CONTRACT CHANGE ORDER NO. 42
 SHEET X OF XX

SAS SUPERSTRUCTURE - CONDUIT PLAN

SAS SUPERSTRUCTURE ROADWAY EASTBOUND LIGHTING AND ELECTRICAL SYSTEMS
 SCALE 1:200

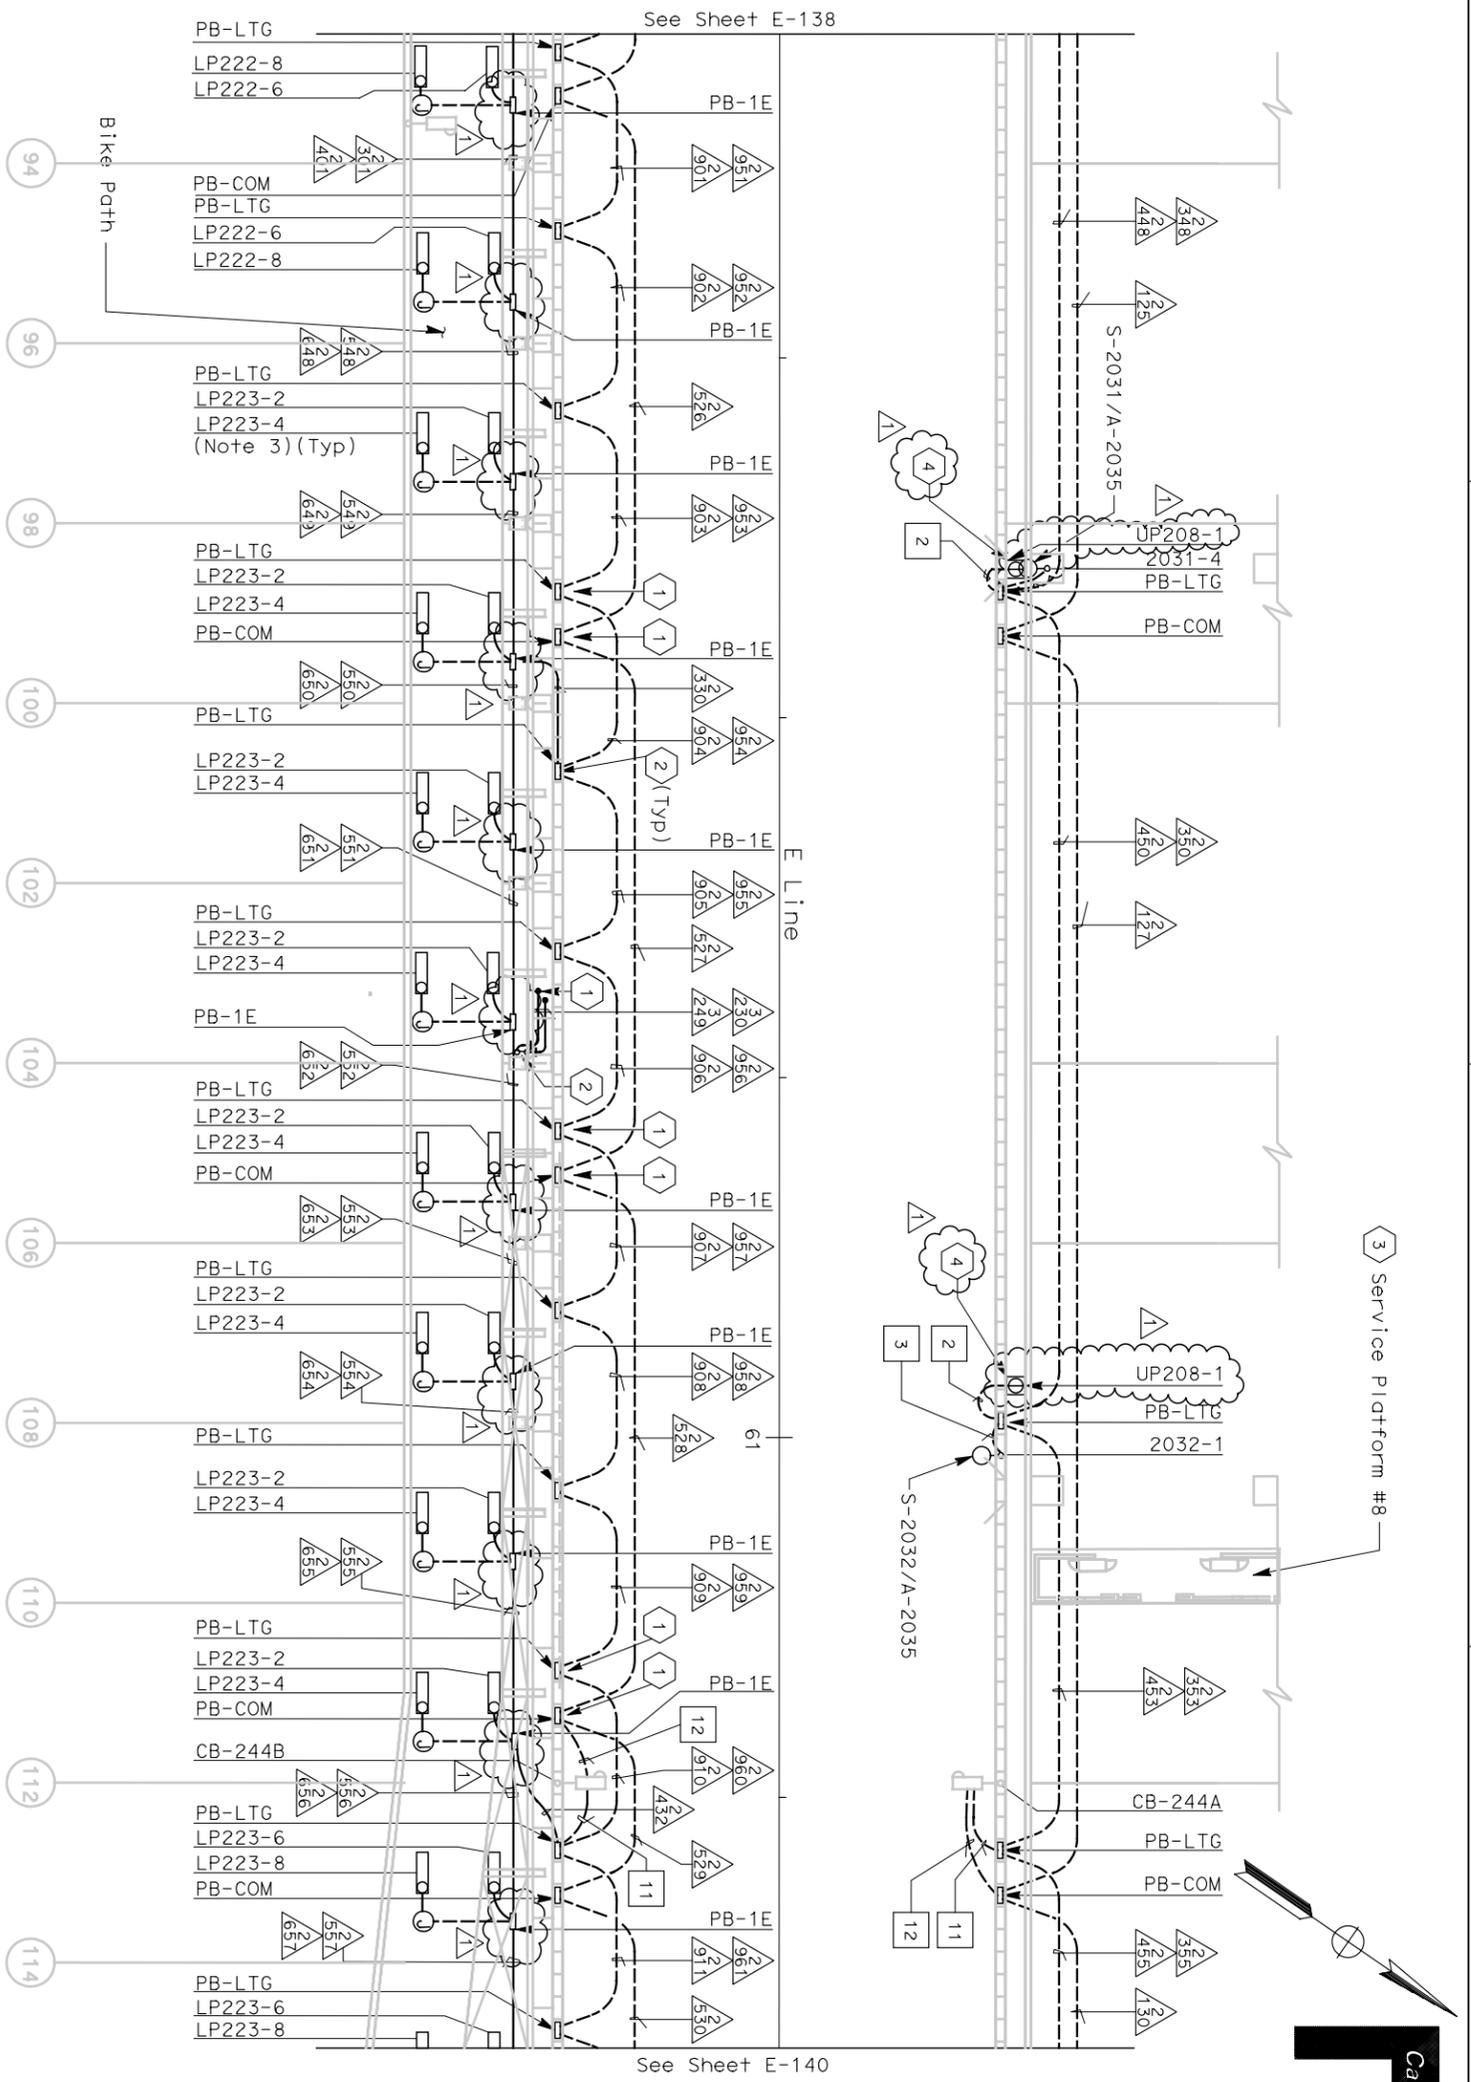
MARK	DATE	DESCRIPTION	BY	CHK	CCO
1	8-06-07	Revision to misc. electric work. Rep. RFL-218, Change roadway barrier receptacle type per RFL-242.	MP	RR	42
